MIL-M-38510/381(USAF)
AMENDMENT 3
24 November 1998
SUPERSEDING
AMENDMENT 2
25 January 1988

MILITARY SPECIFICATION

MICROCIRCUITS, DIGITAL, BIPOLAR, ADVANCED LOW-POWER SCHOTTKY, TTL, CASCADABLE, DECADE COUNTERS, MONOLITHIC SILICON

FIGURE 1. TERMINAL CONNECTIONS (TOP VIEW) - Continued.

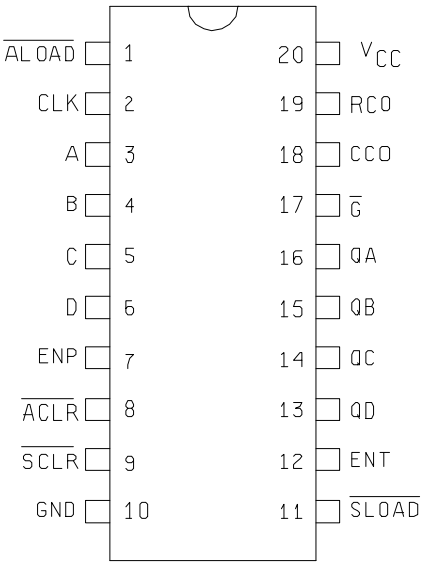
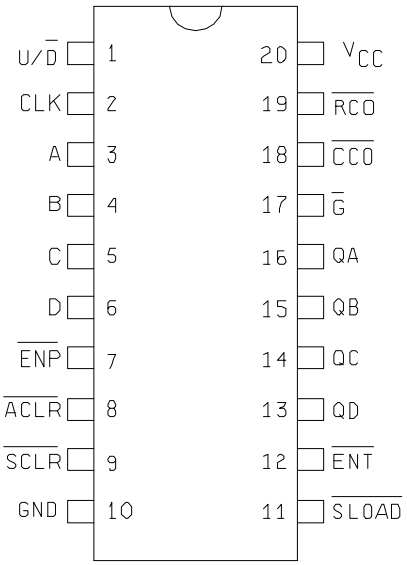
FIGURE 1, device types 04 and 05: Delete "Case 2" and substitute "Cases X and 2".
